**Safety Evaluation Report, Revision 1, of License Amendment Request, dated September 24, 2018, United Nuclear Corporation (UNC) submitted a request to the U.S. Nuclear Regulatory Commission (NRC) to amend its Source Materials License No. SUA-1475 for the former UNC Church Rock uranium mill and tailings site under the requirements specified in Title 10 of the *Code of Federal Regulations* (10 CFR), Part 40, Domestic Licensing of Source Material**

Materials License No. SUA-1475

Docket No. 040-08907

**United Nuclear Corporation**

**Figure 5:** Proposed profile of the future repository and disposal cell in a borrow pit area.

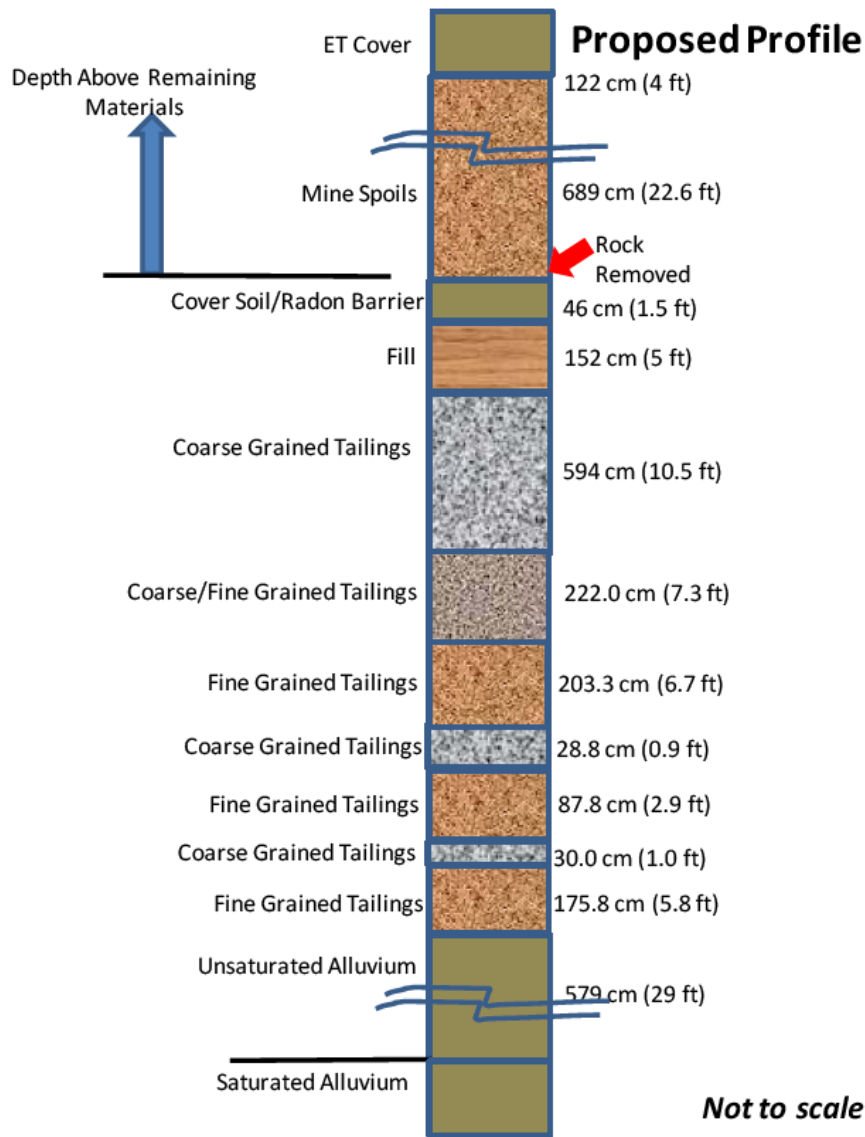
Appendix Y (UNC, 2020e) of the LAR contains the results of the licensee's analysis of the potential effect of the added weight of the mine waste on the underlying mill tailings and subsequently on the underlying groundwater. Mine waste will be disposed of in a repository designed within the footprint of the existing tailings impoundment at the mill site. Rocks and riprap on top of the current cover at the Church Rock site will be removed before placement of the mine waste and later reused at the surface. The original disposal cells with tailings will not be altered and the original radon barrier will also be left in place. Figure 5 shows a profile of the future repository and disposal cell in a borrow pit area (borrow pit 1). Placement of the mine spoils and subsequent ET cover components will place added weight, and thus stress, on the existing tailings material originally placed within the existing impoundment. Appendix Y states that there is a relatively small reduction in porosity in the tailings due to the added weight on the existing impoundment and that the coarse and fine tailings become fully saturated in some of the profiles. However, the licensee states there is no increase in flux into the underlying groundwater from the tailings and therefore no drainage impact into the underlying groundwater. Similar to the UNSAT-H simulation results performed in Appendix G, Attachment G.7, findings from these sensitivity analyses show that the new ET cover components prevent flux while the existing cover did allow percolation into the disposal cell, but no downward flux from the base of the alluvium.

Despite the nearly 12 ft (3.7 m) of saturated fill and cover layers, Figure 16 in Appendix Y shows no downward flux from the base of the alluvium for existing conditions. It appears that the water in the saturated layers above the fine-grained tailings is pulled upwards to the surface to undergo evapotranspiration based on the results of the UNSAT-H simulation. If similar simulated conditions occur near other profiles is not clear. Figure 21 representing Profile B8 shows an increase in moisture in the coarse-grained tailings but no saturated condition in the fill layer below the root zone of the existing cover. This makes sense since the fill layer has a calculated initial suction, or soil matric potential, value in the millions of negative centimeters (i.e., thousands of times drier than any other layer within the system) and takes over 60 years in the sensitivity runs to reach moisture levels comparable to other layers (see Figure 21). Unfortunately, the sensitivity runs end when the fill layer has reached a more average soil suction value, and a conceptual model of water flow after this point is unclear. Also unclear is why the fill layer in Profile B2 should become saturated as described above in a mere dozen years with an initial soil matric potential value of -2,692,958,106.4 cm, or -1,060,200,000 in, (i.e., similarly dry as the fill in profile). This lack of clarity is part of the reason the NRC staff is modifying the license condition related to ground water monitoring. This is further discussed below in Section 3.7.4.

The profile run that does allow a hypothetically small but discernable downward flux of water through the base of the alluvium is Profile B11 as simulated in the sensitivity cases. Tables A7 and A8 in Appendix Y show a drainage of approximately half a centimeter per year for the first 20 years. Figure 19 in Appendix Y presents this drainage in a more visual form where the annual flux from the base of the alluvium are positive values for both the existing disposal cell and the future repository/disposal cell. Current UNC/GE designs show less than 1.5 m (5 ft) of cover sediment at the surface, but no mine waste being placed above Profile B11, so that consolidation is minimal (0.03 m or 0.1 ft). Nevertheless, Section 7 in Appendix Y states that drainage water from anywhere below the disposal cell will be captured and held within the alluvium making that unit a potentially significant barrier to increased contaminant concentrations in the groundwater. This difference between the narrative and analysis results is part of the reason that the NRC staff is modifying the license condition related to ground water monitoring. This is further discussed below in Section 3.7.4.

**Figure 6:** Hypothetical SWCCs before and after consolidation.

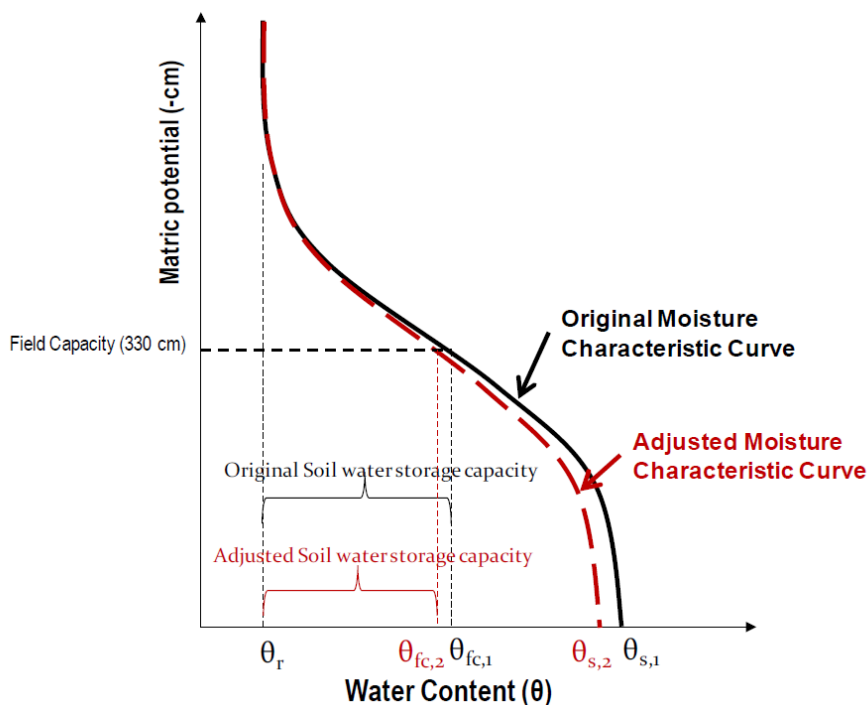
Section 7 in Appendix Y discusses the boundary condition at the base of the alluvium being a unit gradient boundary condition and therefore “forcing drainage based on steady-state conditions at the bottom node” and that it “does not necessarily mean there is actually drainage from the alluvium.” A unit gradient lower boundary condition assumes that free drainage exists in the vertical direction (i.e., downward flow due to gravity), and it implies that water that passes downward across the boundary does not return to the simulated domain. This is a standard boundary condition for unsaturated flow models besides a fixed water table or seepage boundary. Drainage water is part of the water budget of the model as seen in the tables of Appendix A of Appendix Y and should be accepted as drainage since water not bound to the soil particles will be pulled downward by gravity.

Although field capacity is unchanged, the retention curve has changed so that the adjusted soil water storage capacity is smaller than the before consolidation. [Source: Figure 6 from Appendix Y of the LAR (UNC, 2020e)]

**Figure 10:** PMP temporal accumulations for various durations

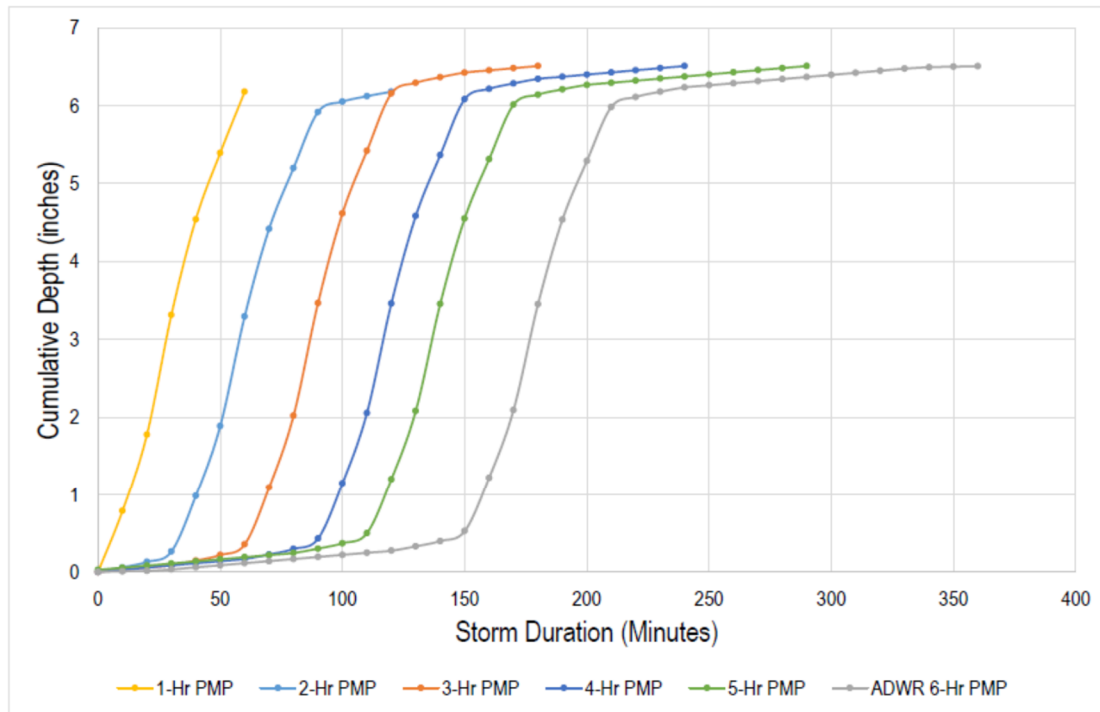
As presented in Figure 10 below, the licensee’s intensity-ratio method is to distribute a 1-hour peak precipitation at the middle of temporal distribution of other PMP events as the same pattern of the 1-hour peak precipitation within the 6-hour PMP event.

**Figure 11:** Location of the proposed riprap chute in the Pipeline Arroyo and the existing Branch Swale H and two evaporation ponds

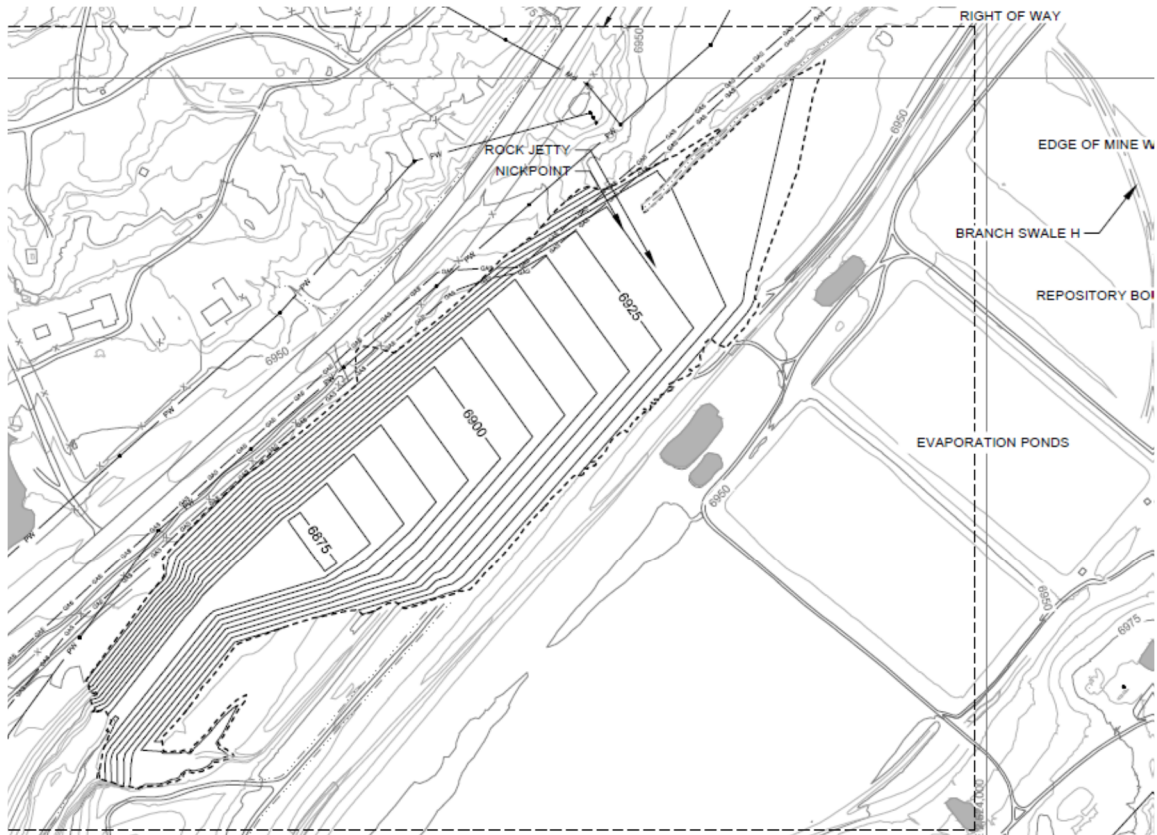
The licensee used a three-dimensional model to simulate steady flow conditions within the riprap rock chute and the sunken basin for multiple flood events. The simulation results indicate that the PMF produces a maximum flow speed of 27 ft/s near the right bank (northern side) of the riprap chute (Figure 3 of Supplement I.7.1 of Attachment I.7 of Appendix I, Volume I). The licensee used this flow velocity as a main velocity to design the riprap rock protection for the chute and the sunken basin. The licensee selected other velocities lower than 27 ft/s as secondary options to design riprap rock protection for low flow velocity areas.

During its review, the NRC staff evaluated several different aspects of UNC's design, including: (1) the variation in the depth-average velocity along the cross section given the approximately uniform slow depth indicated on Figures 2 and 3 of Attachment I.7; (2) the channel roughness using a 12-inch height; (3) observed high flow velocities larger than 3 ft/s (Figures 2 and 3; Design Drawing 09-10) in some local areas without riprap rock protections; (4) the length of the hydraulic jump at the bottom of the riprap chute; (5) balancing of sediment transport between the inlet and outlet of the designed basin; and (6) mesh size in the 3D model. The licensee's approach to each of these aspects of the design and the NRC staff's conclusion is summarized below (the licensee's approach is summarized from UNC, 2019b).

3. Observed high flow velocities larger than 3 ft/s (Figures 2 and 3; Design Drawing 09-10) in some local areas without riprap rock protections.

*In design drawings 9-09, 9-10, and 9-11, Stantec extended the apron length to the riprap basin to 380 feet. This is sufficient to provide erosion protection beyond the length of the hydraulic jump. The revised drawings are included as Attachment 3 to this submittal.*

The NRC staff recognizes that the licensee provided the updates of Design Drawing sheets 9-09 through 9-11 of Section 9 of Volume II of the LAR to indicate riprap rock would be extended for preventing the downstream area of the basin outlet from erosion. The licensee stated that monitoring an area downstream of the outlet basin in the Pipeline Arroyo be performed to identify possible instabilities with the potential to migrate back toward the riprap basin due to downstream channel bank erosion. Considering the NRC staff's concerns noted in this SER Section 4.3.3.1 and SER Section 4.3.3.4, the NRC staff proposes License Condition 34C in license SUA-1475. The NRC staff would impose this condition to require the licensee to document the as-built performance of the cover system and riprap chute in the Pipeline Arroyo to demonstrate that they have been constructed correctly and perform as expected. Additionally, this observation period will confirm assumptions supporting the design by providing: 1) a better understanding of how the uncertainties of the forces with the hydraulic jump will impact the riprap chute in the long-term; 2) confirmation that the riprap chute has been constructed correctly; and (3) information on future long-term maintenance needs.

**Figure 12:** Layout of drainage system in the proposed repository area of the mill site

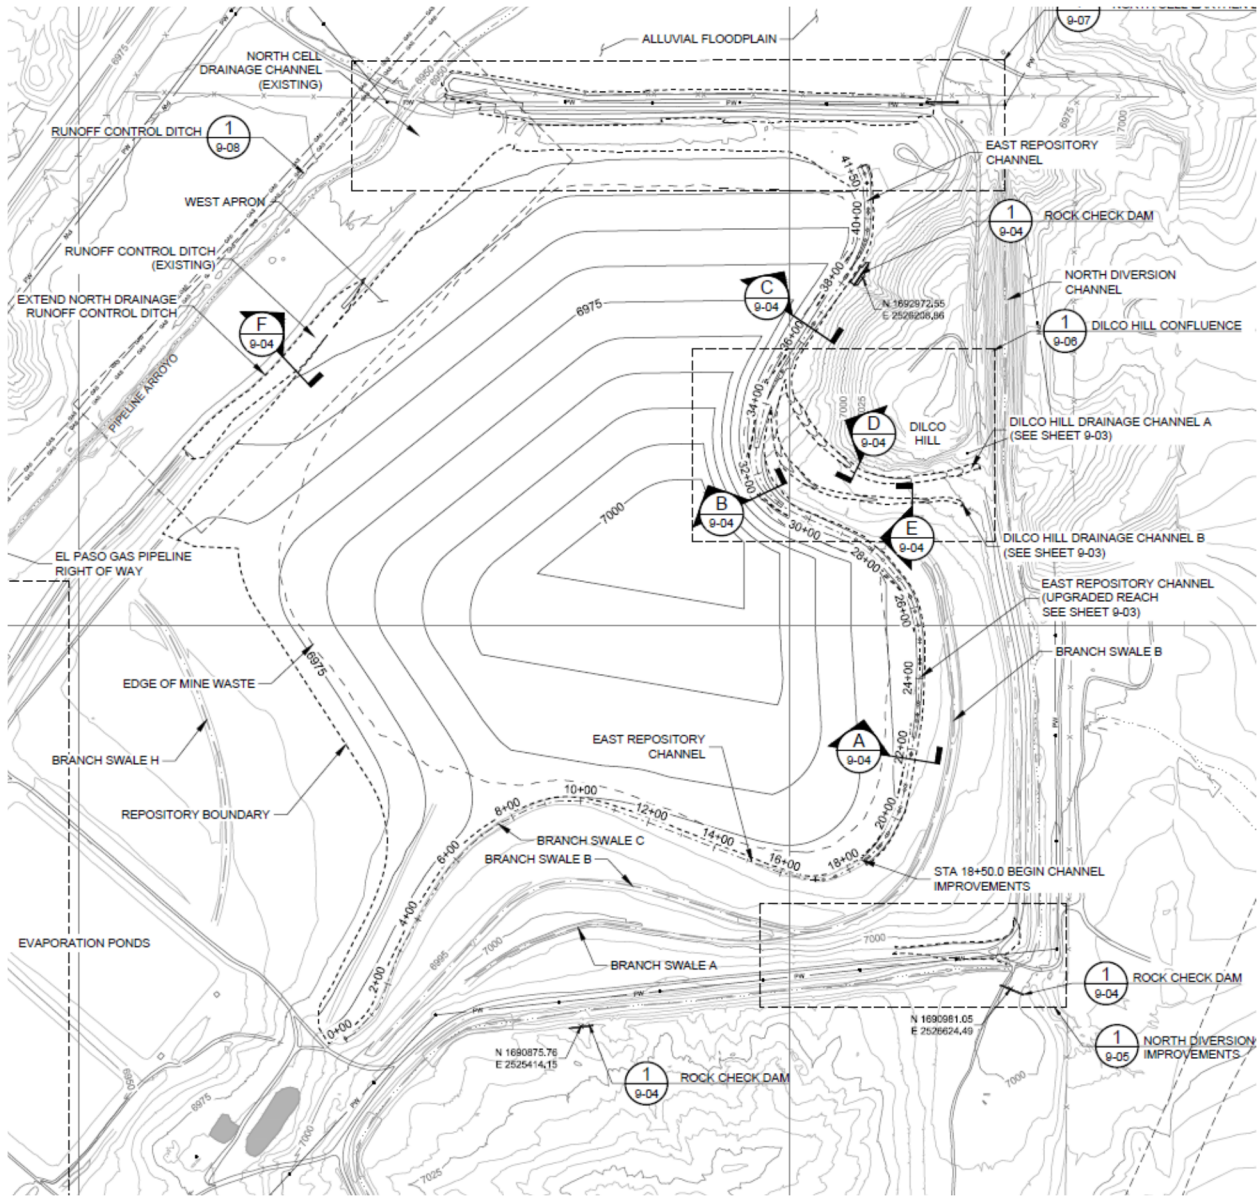
The licensee proposed the lower East Repository Channel and two branches, Dilco Hill Channels A and B, to convey surface runoff from the Church Rock Mill Site Repository and Dilco Hill areas to the existing North Cell Drainage Channel (see Figure 12 below).

The repository area will be overlaid by a proposed mine waste layer and a cover layer as part of the Removal Action (RA) plan. The proposed lower East Repository Channel will follow the existing path of the upper reach of the North Cell Drainage Channel. The licensee presented the channel alignment, channel profiles, and typical channel cross sections in the Design Drawings 9-02 through 9-06 (Volume II Design Drawings of the LAR,) for the lower East Repository Channel and the two Dilco Hill Channels A and B. The Design Drawing 9-02 also shows the locations of Branch Swale H, which has no outlet (see middle left edge of Figure 12), and Runoff Control Ditch, which connects to a natural drainage downstream along the northwest edge of the mill site repository area.
